Castle Wind Energy Facility and associated infrastructure, Northern Cape Province

Motivation for amendment of Environmental Authorisation

DEA Ref.: 14/12/16/3/3/2/278

July 2019

Figure 5.1.1: The position of known Verreux's Eagle nests & 3km buffers relative to the proposed site. (A3 Map included in Appendix F).²

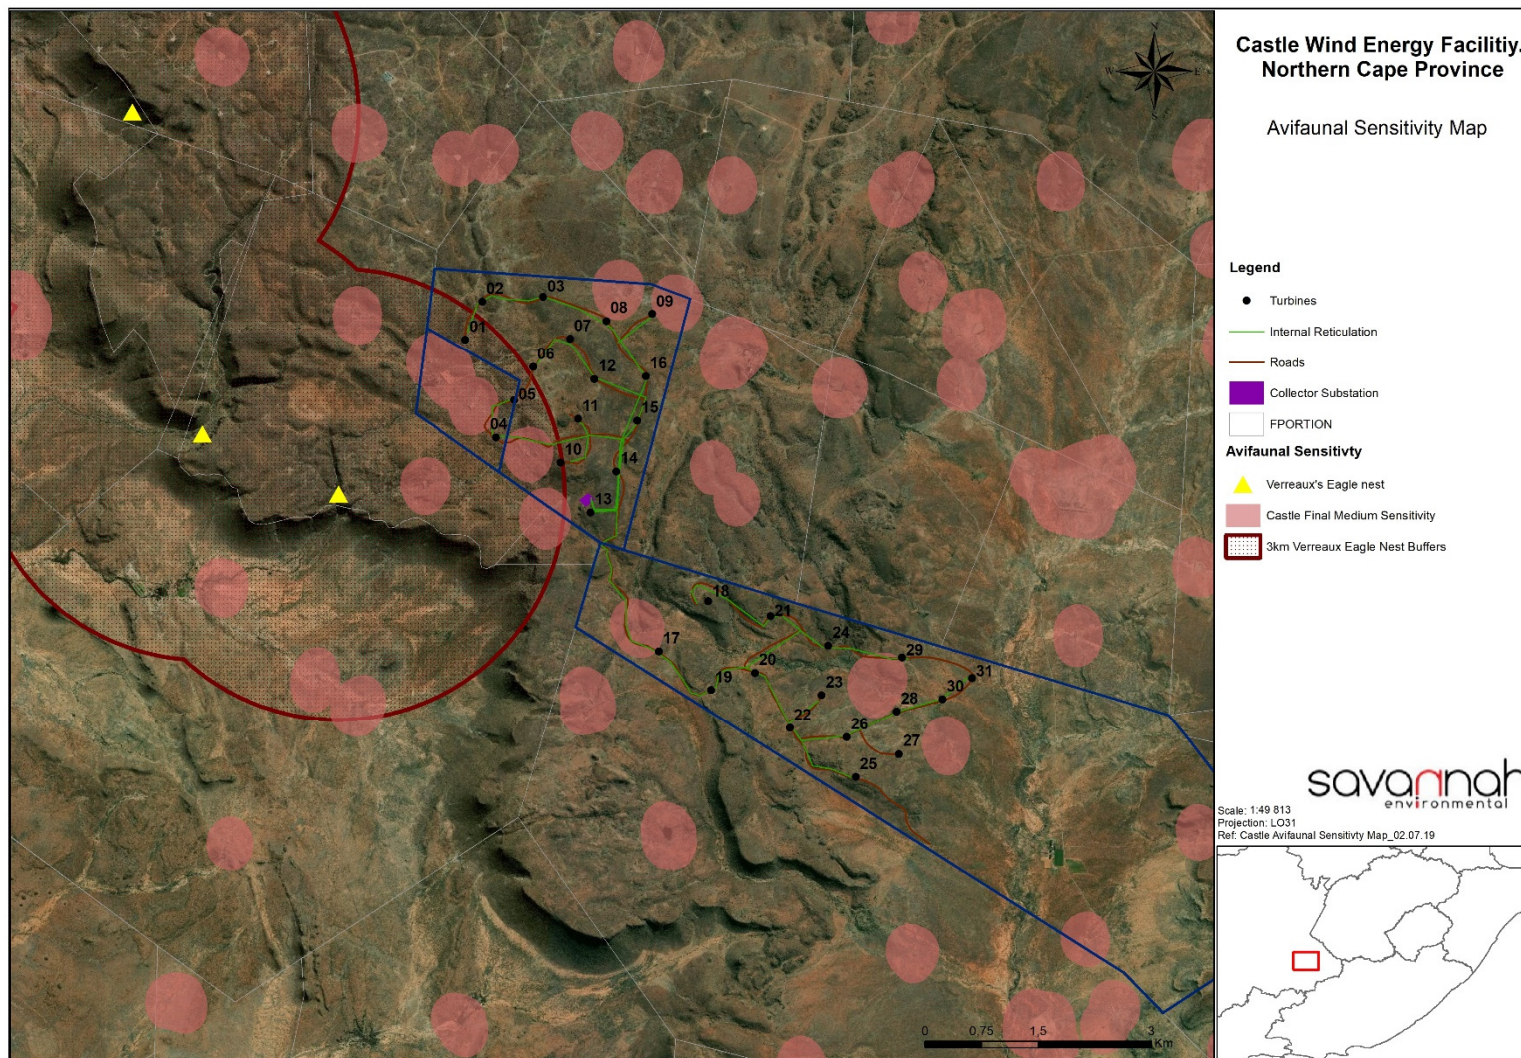
Verreux's Eagles have been recorded at the Castle WEF project site and three known Verreux's Eagle nests were identified during the pre-construction monitoring. The Verreux's Eagle nests are indicated relative to the Castle Wind Farm in Figure 5.1.1. The closest of these nests is relevant since it is approximately 2.2km from the nearest turbine. In order to adhere to the 3km no-go buffer, the removal/relocation of Turbines 1, 4 and 5 during final design and micro-siting is recommended by the specialist. Should this buffer be adhered to there will be no need for further avifaunal survey work on site. If infrastructure is constructed within this 3km buffer area, it would necessitate further survey work on site. The avifaunal specialist would need to return to site to update their knowledge and understanding of the location of Verreux's Eagle nests in the area before making a final finding. It will also require data from the adjacent operational Longyuan Mulilo De Aar 2 North Wind Energy Facility to get a better understanding of the Verreux's Eagle population dynamics in the area.

» ² Turbines 1, 4 and 5 will need to be relocated/removed during final design and micro-siting in order to adhere to the 3km buffer.

Figure 5.2.1: Due to the updated guidelines, a number of turbines are now located in High Bat Sensitivity areas. These turbines will need to be relocated during micro-siting or removed from the layout (**A3 Map included in Appendix F**).

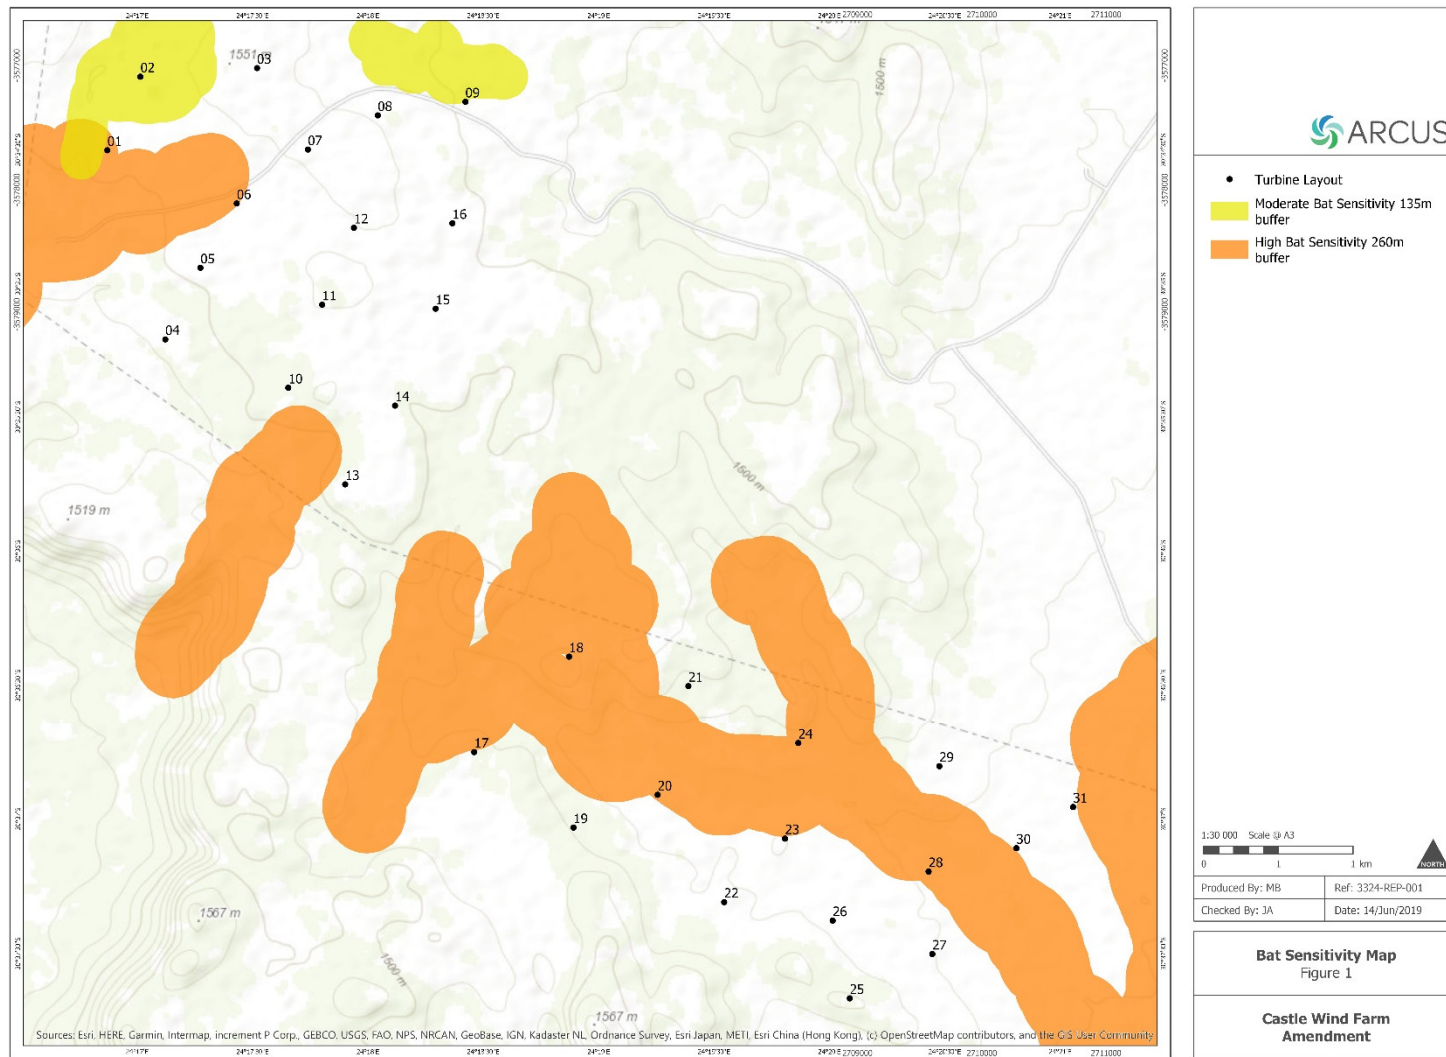
Using the formula above, the 150 m high sensitivity buffer would need to be either 184 m or 200 m to blade tip. The 100 m moderate sensitivity buffer would need to be either 126 m or 132 m to blade tip. Based on this, some turbines are now located in bat sensitive buffers (Table 5.2.1). The guidelines applicable during the initial Bat Impact Assessment (Animalia, 2014) stipulated a buffer of either 100 m or 150 m (Sowler and Stoffberg, 2012). Subsequent to the initial Bat Impact Assessment revised guidelines have been released (Sowler et al. 2017). These guidelines recommend a minimum buffer of 200 m to blade tip for important bat features. The specialist recommended that based on the bat activity at the site, the moderate sensitivity buffer should be sufficient at 100 m. The increase in the high sensitivity buffer from 150 m to 200 m results in some turbines being located in buffer zones (Table 5.2.1 and Figure 5.2.1). These turbines will need to be relocated from the layout during final design and micro-siting.

Unchanged 100m Moderate Sensitivity Buffer (to blade tip)	90 m hub height, 55 m blade (126 m to turbine base)	150 m hub height, 100 m blade (135 m to turbine base)
Moderate Sensitivity	1 (T2)	2 (T2, T9)
Previous 150 m High Sensitivity Buffer (to blade tip)	90 m hub height, 55 m blade (184 m to turbine base)	150 m hub height, 100 m blade (200 m to turbine base)
High Sensitivity	1 (T28)	3 (T1, T24, T28)
Current 200 m High Sensitivity Buffer (to blade tip)	90 m hub height, 55 m blade (239 m to turbine base)	150 m hub height, 100 m blade (260 m to turbine base)
High Sensitivity	4 (T1, T20, T24, T28)	6 (T1, T6, T18, T20, T24, T28)

The proposed amendment is unlikely to alter (increase or decrease) the impact significance as assessed during the EIA process. These impacts would remain the same assuming the mitigation measures proposed in the pre-construction bat monitoring report and EMPr are adhered to. The mitigation measures included the implementation of operational bat monitoring and assessing the need for curtailment and the avoidance of sensitive areas for bats by adhering to the sensitivity map (Figure 5.2.1). No additional mitigation measures are required.

In order to maximise ground clearance due to bat activity that was recorded lower to the ground, a wind turbine with a 150m hub height is recommended as the preferred option by the specialist. The amendment will not change the findings of the EIA report and the amendment is considered to be acceptable from a bats perspective, provided that during final design and micro-siting all turbines are located outside of the bat sensitivity buffer zones calculated according to the formula in section 5.2.1. The final layout must be submitted to the DEA for approval in terms of Conditions 12 and 13 of the Environmental Authorisation.

Figure 5.3: Viewshed analysis represents the potential total visual exposure of the original turbine dimensions (illustrated in green) compared to the proposed new turbine dimensions (illustrated in red).

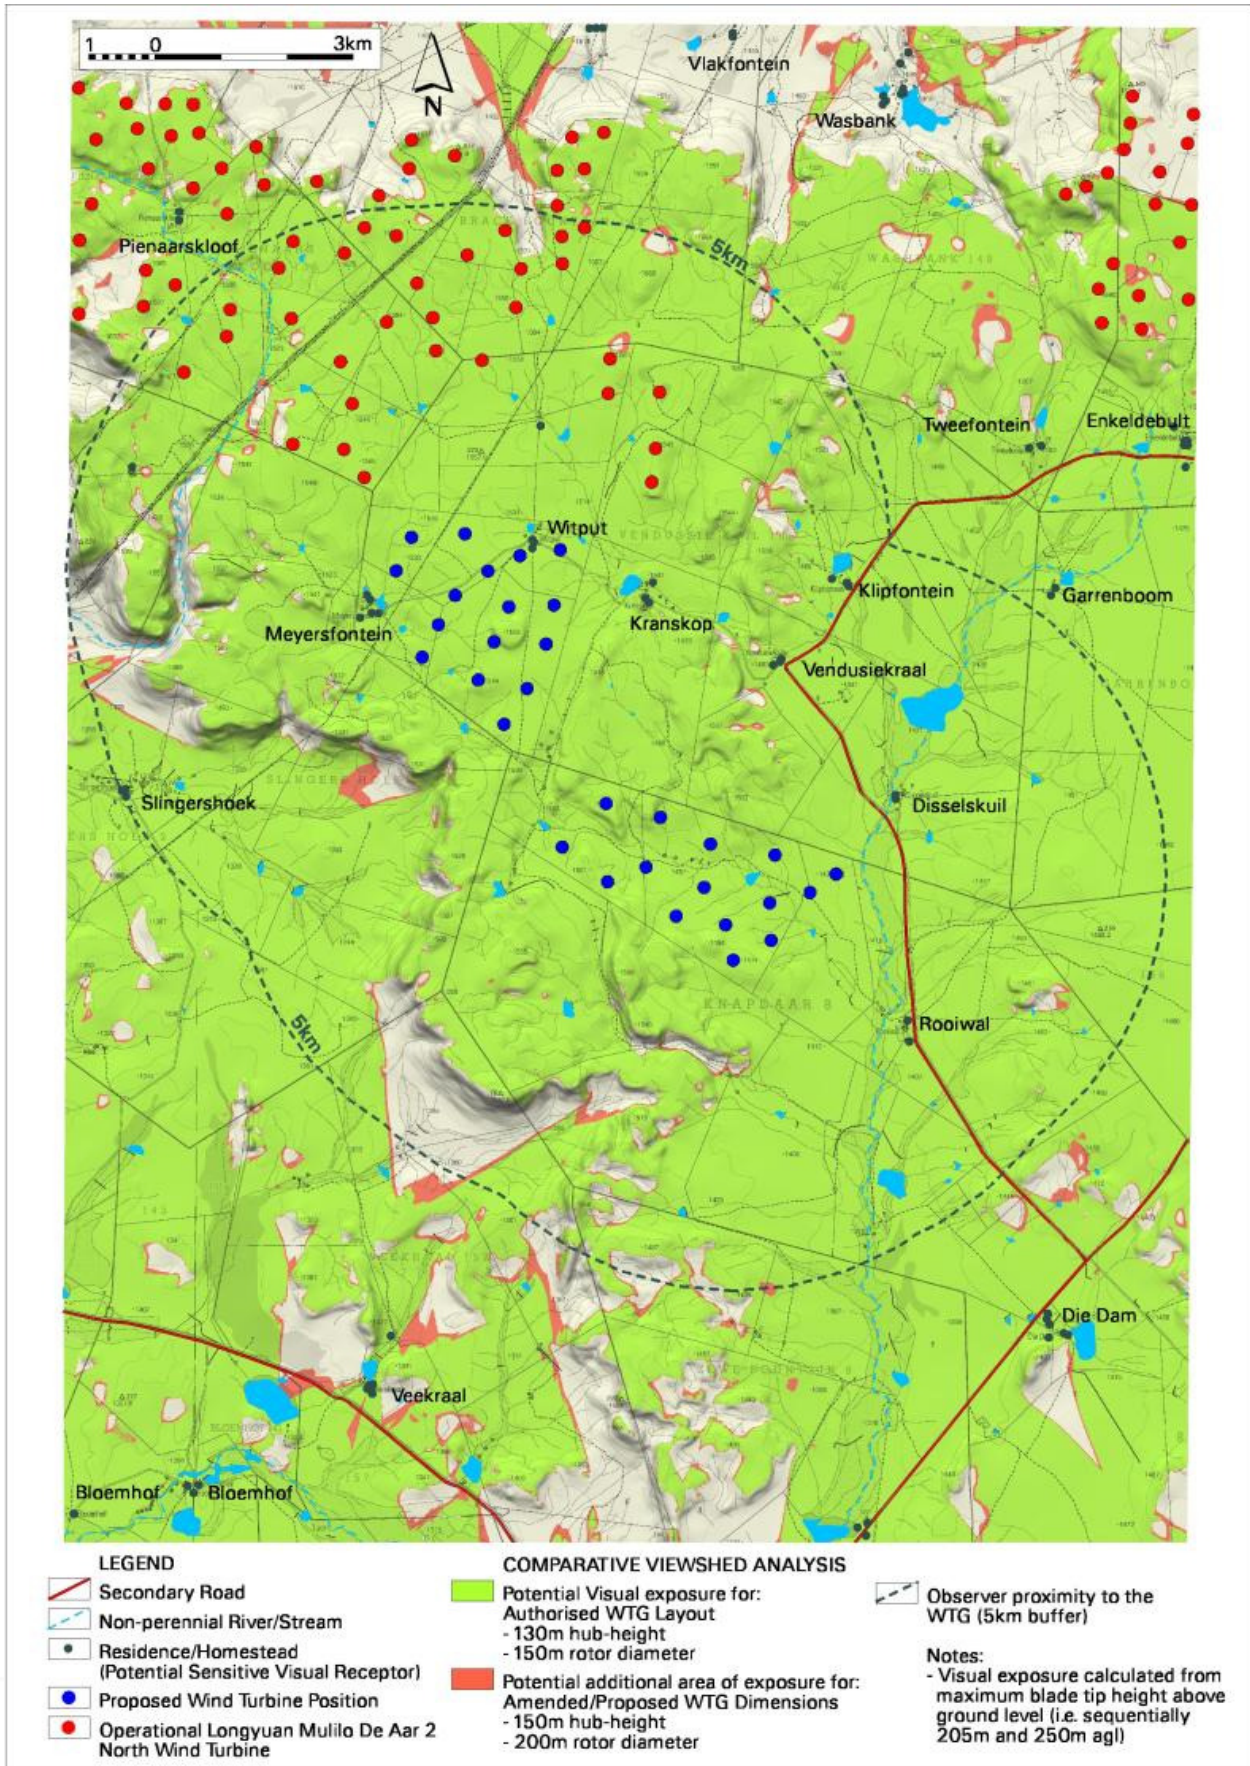
The visibility analysis was undertaken from each of the wind turbine positions (31 in total) at an offset of 205m (maximum blade tip height) was used. This result indicates the total visual exposure from the Visual Impact

Assessment during the EIA process (indicated in green). The 250m maximum blade tip height was used as input and the visual exposure is shown in red. The results of the visibility analyses are displayed on **Figure 5.3** below. The visual exposure increased by 18% and the specialist concluded that this would have a relatively small influence on the overall visual exposure. The surface area exposure increased from **325km²** to **336km²** with the increased dimensions in the proposed amendment. This constitutes a **3%** increase in potential visual exposure which was also concluded to be of low significance.

No additional sensitive visual receptors located within the area of increased visual exposure were identified. The increased area of visual exposure does not include a significant portion of additional exposure to the secondary roads within the study area.

It is expected that the wind turbine structures, both the original dimensions and the proposed increased dimensions would be equally visible and noticeable from both the roads and homesteads identified above, therefore signifying a negligible change to the potential visual impact.

Figure 5.4: NSD in relation to the wind turbines of the Castle WEF (refer to **Appendix F** for A3 Map).

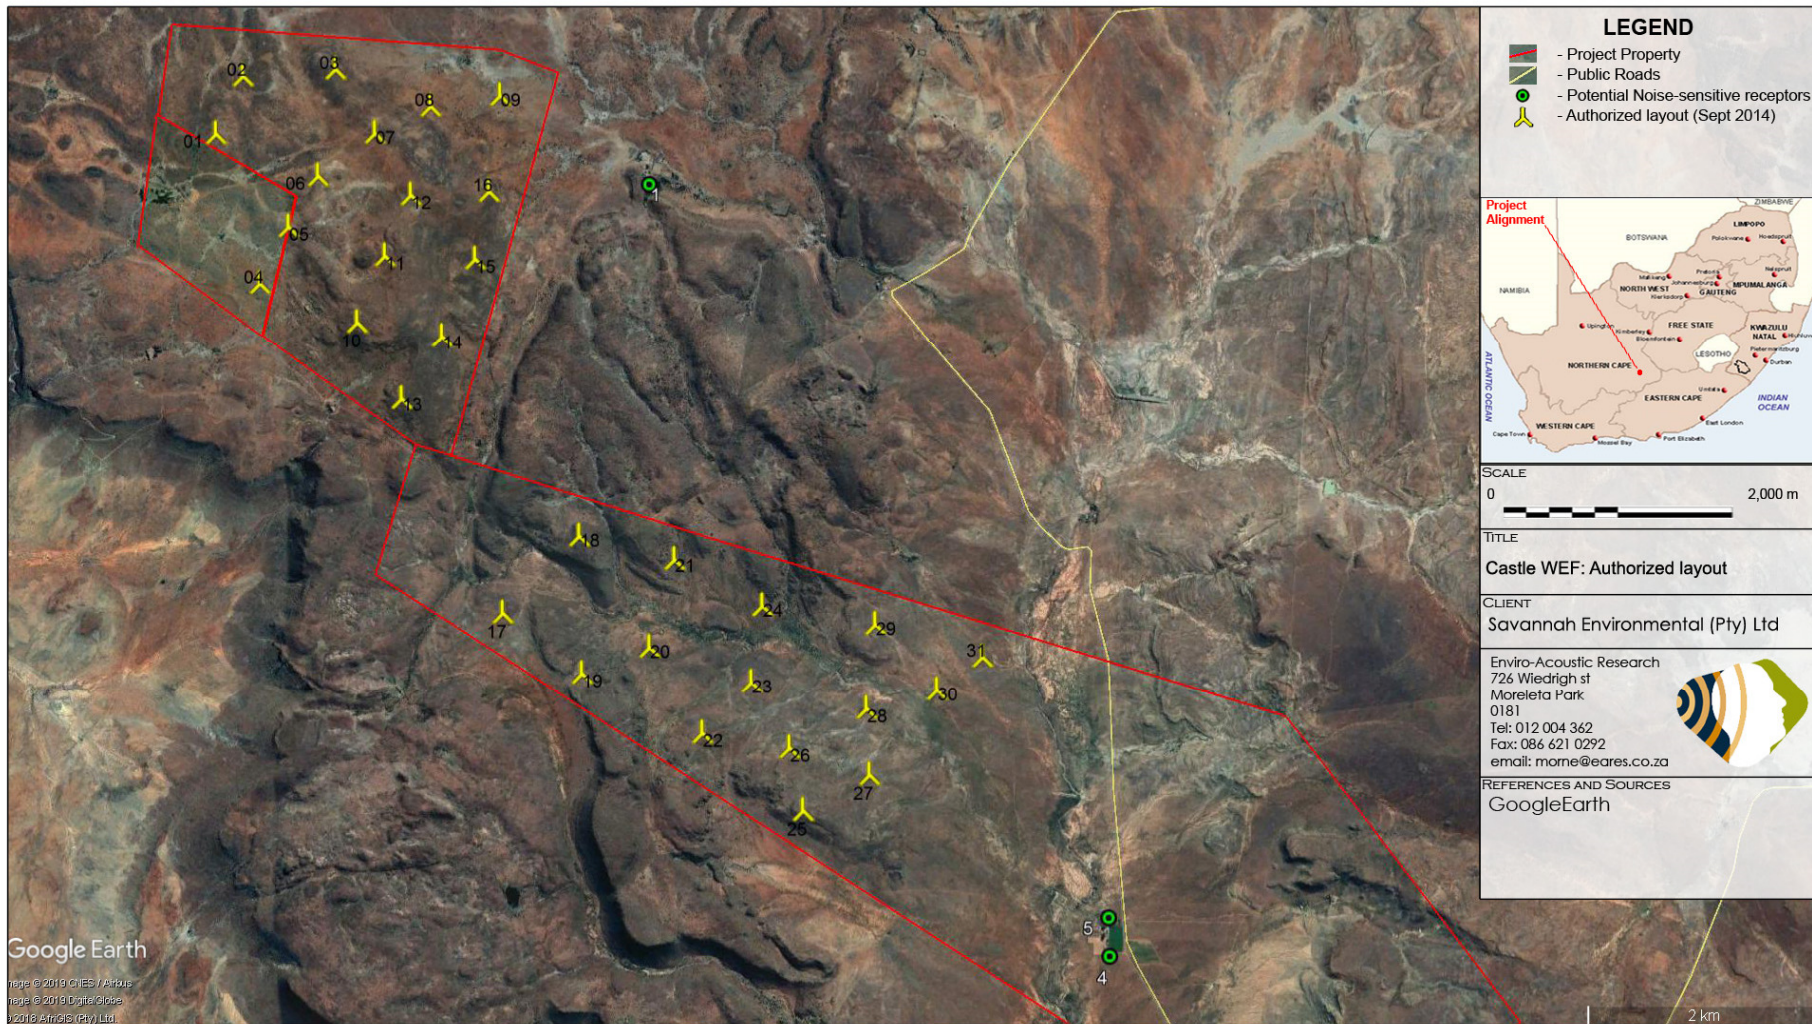
The noise amendment comment letter (**Appendix D**) addresses the potential changes in noise impact significance in terms of the proposed amendments by comparison with the original assessment undertaken in 2015 as part of the EIA process. The 2015 Noise Impact Assessment indicated that the proposed wind farm will have a noise impact of a low significance on all potential noise-sensitive developments in the area during both the construction and operational phases. The wind turbine used in this assessment was the Vestas V112 3.0MW wind turbine (for all wind speeds). This wind turbine has a maximum sound power generation level of 107.0 dBA. The projected maximum noise levels were projected to be less than 36 dBA at the closest NSD. These NSDs are shown in **Figure 5.4** below.

Considering the fact that proposed wind turbines are more than 1 000m away from any potential noise-sensitive receptors and taking into account the potential noise impact, the specialist concluded that the change will not change (i.e. increase or decrease) the significance of the noise impact and the impacts will remain of a low significance. The amendment is acceptable from a noise perspective and no additional mitigation measures are required.

Figure 9.1: Wind farm layout with updated specialist environmental sensitivities (A3 Map included in **Appendix F**)³

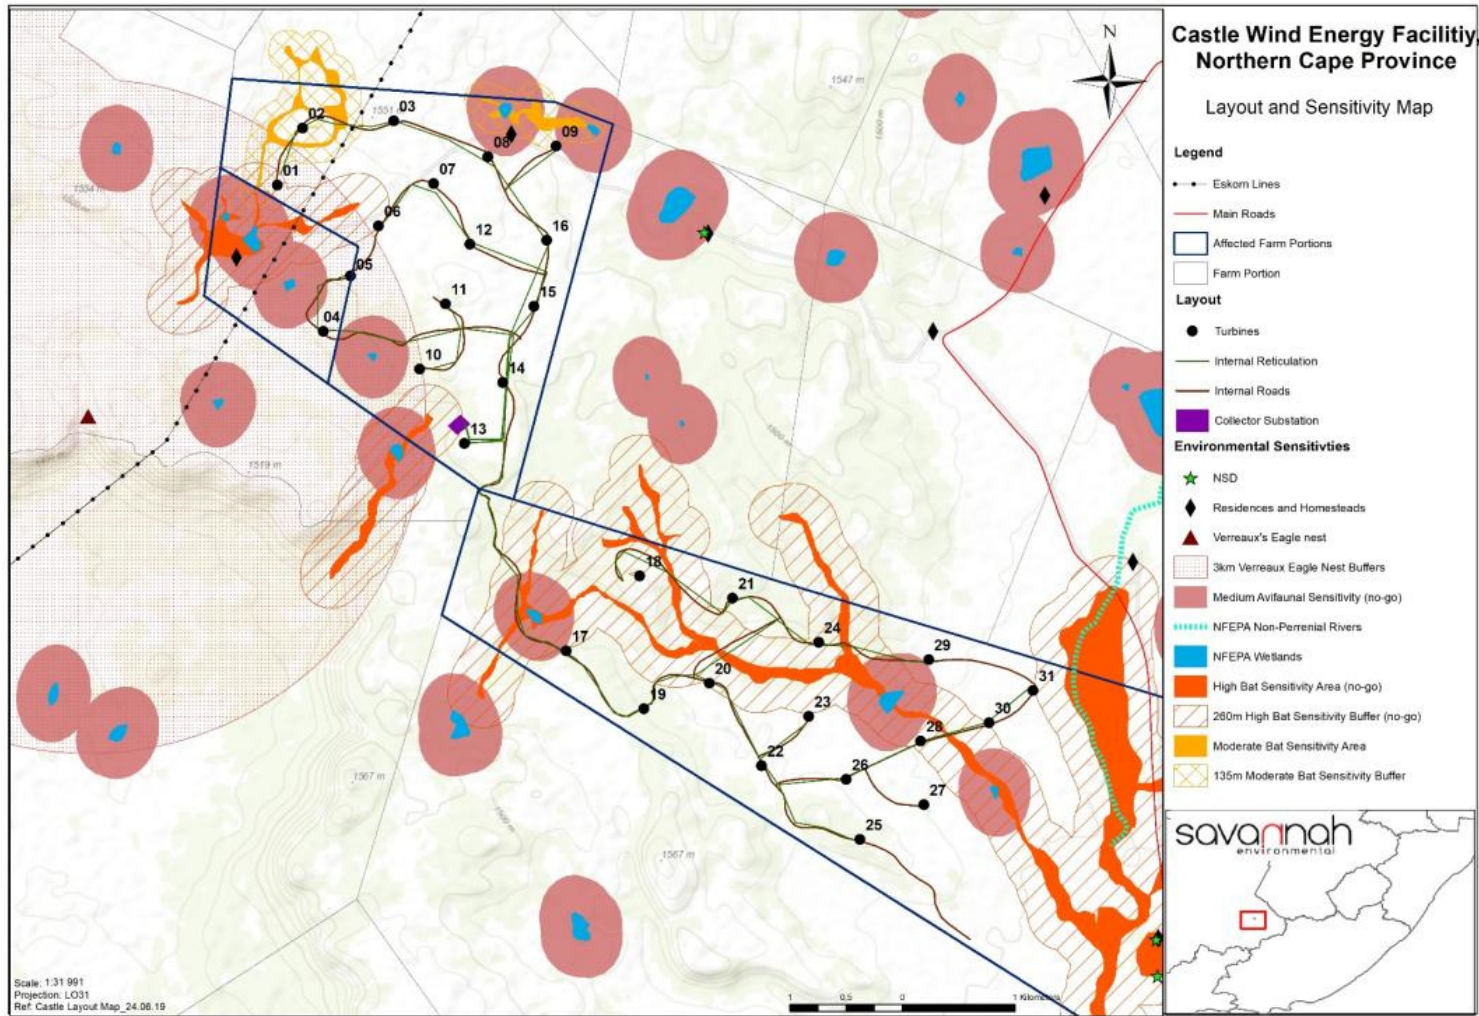
³ No Additional sensitivities were identified during the current amendment process. The Verreaux's Eagle buffer was added during the amendment process due to new guidelines that came into effect and the bat sensitivity buffer was increased in order to be in line with current guidelines.

The Bats specialist concluded that it is unlikely that the amendments to the turbine dimensions proposed for the Castle WEF would change (i.e. increase or decrease) the current rated impacts to bats. This is because they are already high before mitigation and low after mitigation. Due to the proposed change in rotor size, the buffer areas were recalculated. This resulted in some turbines being located in bat sensitive buffers (refer to Figure 5.2.1 and Figure 9.1). These turbines should be relocated/removed during final design and micro-siting.
